EDDC / Regulation 19 consultation response form / March 2015

Submission by Tony Burch, [REDACTED]

Policy AR03: Coastal Change Management Areas (CCMAs) / Policy Map for Sidmouth CCMA along Cliff Road and for the cliffs immediately to the west and east of Sidmouth.

Figure 7: Sidmouth East Beach historic and predicted erosion lines

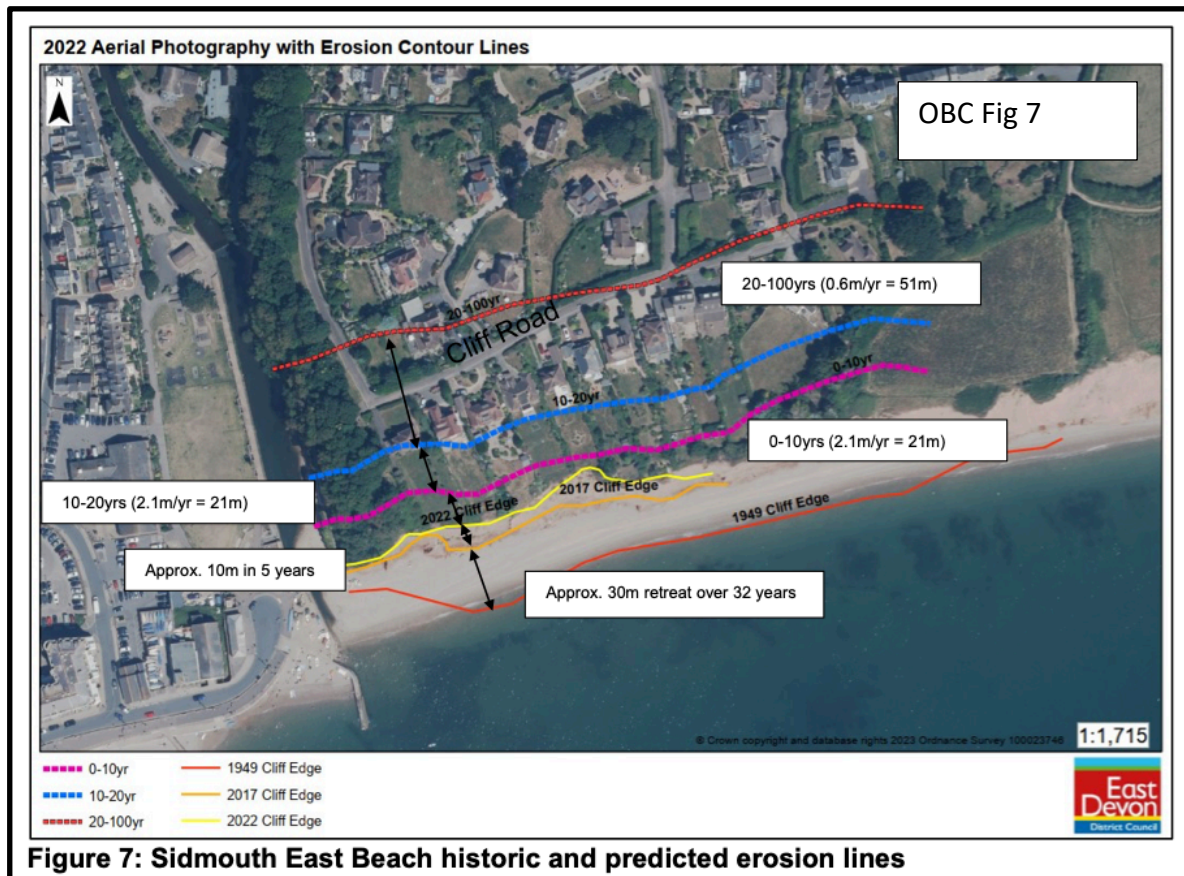
Please note:

- 1) the labels [0-10 yrs. (2.1m/yr = 21m)], [10-20 yrs. (2.1m/yr = 21m)] and [20-100 yrs. (0.6m/yr = 51m)] for future reference.
- 2) The label [Approx. 30m retreat over 32 years] appears to apply to the retreat between 1949 and 2017 cliff lines, in which case the label is not correct because it is 68 years between 1949 and 2017. The LPA were asked if this error made any difference to predicted erosion lines. They did not answer the question.

- the underlining and the emboldening are mine
- the "revised rate of -2.1m / year between year 0 to 20 years and 0.6m / year between year 20 and 100" is exactly the same as on OBC Fig 7 above, except for the typo error '-2.1' which should be '2.1'

Fig 1 - Showing the 10 transects T30 to T342 along East Cliff, 8 of which are along Cliff Road.

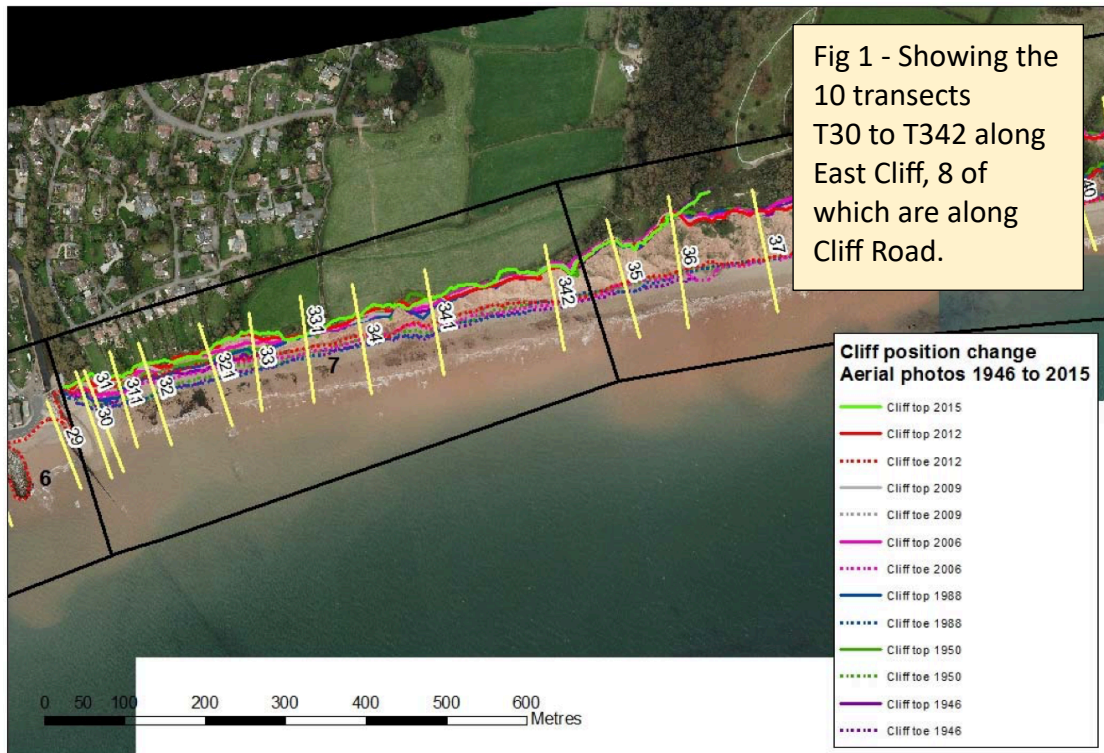
1. The ‘Halcrow calculation’ that was updated, involved the measurement of cliff recession along ten transects T30 to T342 (see glossary Fig 1)
2. Hence transect 31 is the worst of the 10 transects along East Cliff.

CCMA along Cliff Road. The amended CCMA along Cliff Road runs from just before T30 to just past T331

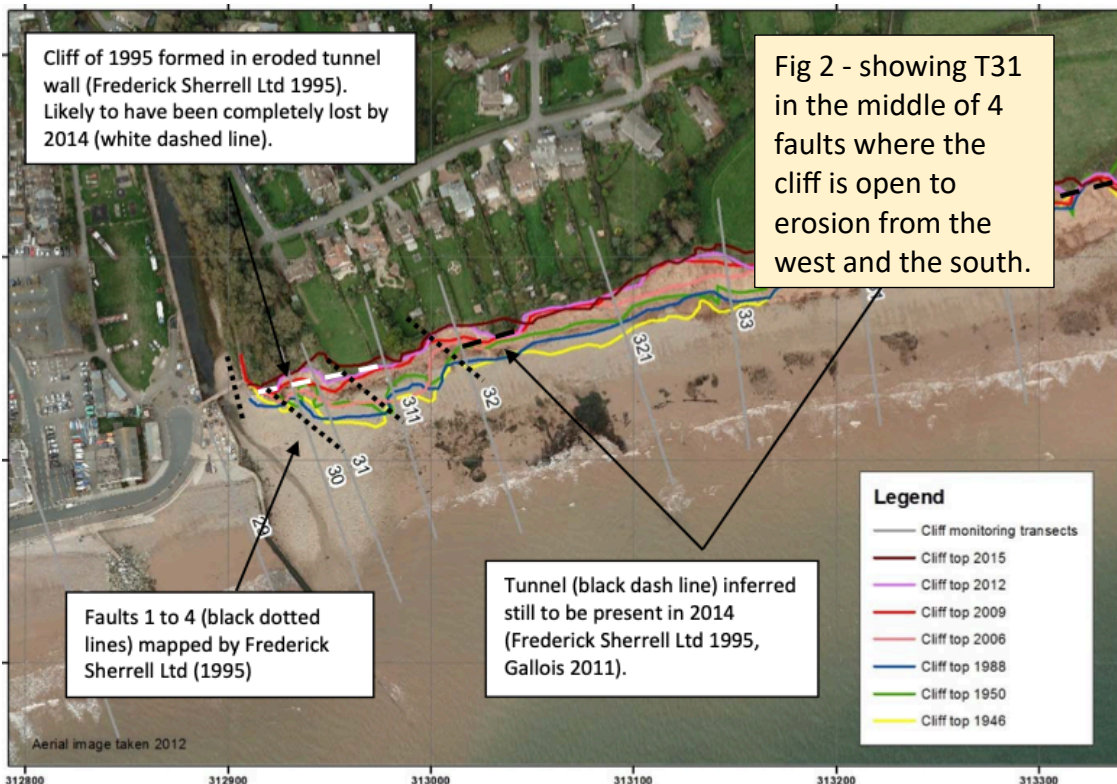
3. T31 is at the far western end of East Cliff in the middle of 4 faults (see Glossary Fig 2) hence it is not representative of erosion along the whole of Cliff Road.

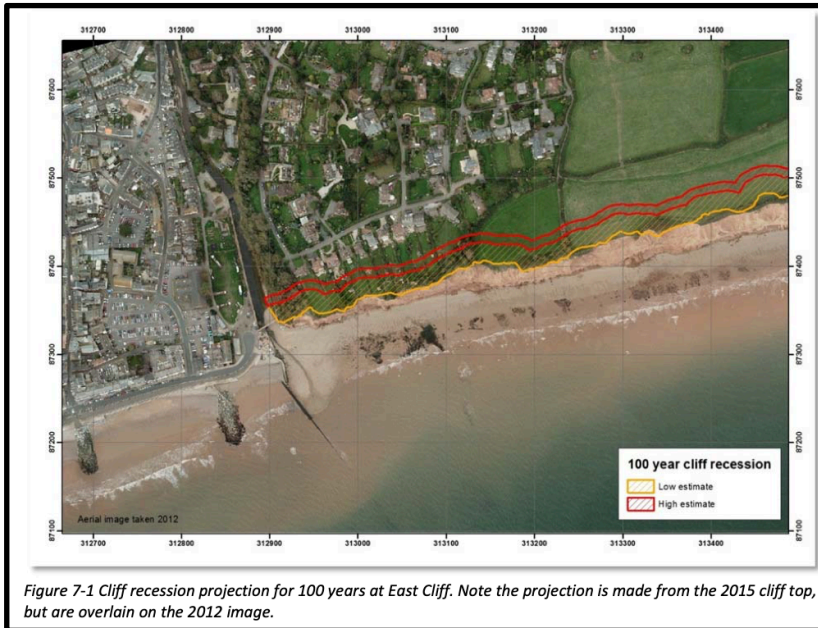
1. Draw the northern boundary of the CCMA along Cliff Road in accordance with the 100-year cliff recession line as shown in Figure 7-1 on page 109 of the 2017 BMP’s Baseline Coastal Process report < <https://rb.gy/zw3vv7>>, where detailed, solid evidence for Figure 7-1 exists to justify using it to draw the CCMA along Cliff Road. Fig 7-1 is reproduced below.

The predicted erosion rate in the BMP is based on a publicly available and detailed analysis of 67 years of recorded erosion, whereas the OBC rate is based on the sentence ...*These rates were **updated** to use **more recent data**, as cliff erosion **appears** to have accelerated in the past decade....* for which there is no evidence.
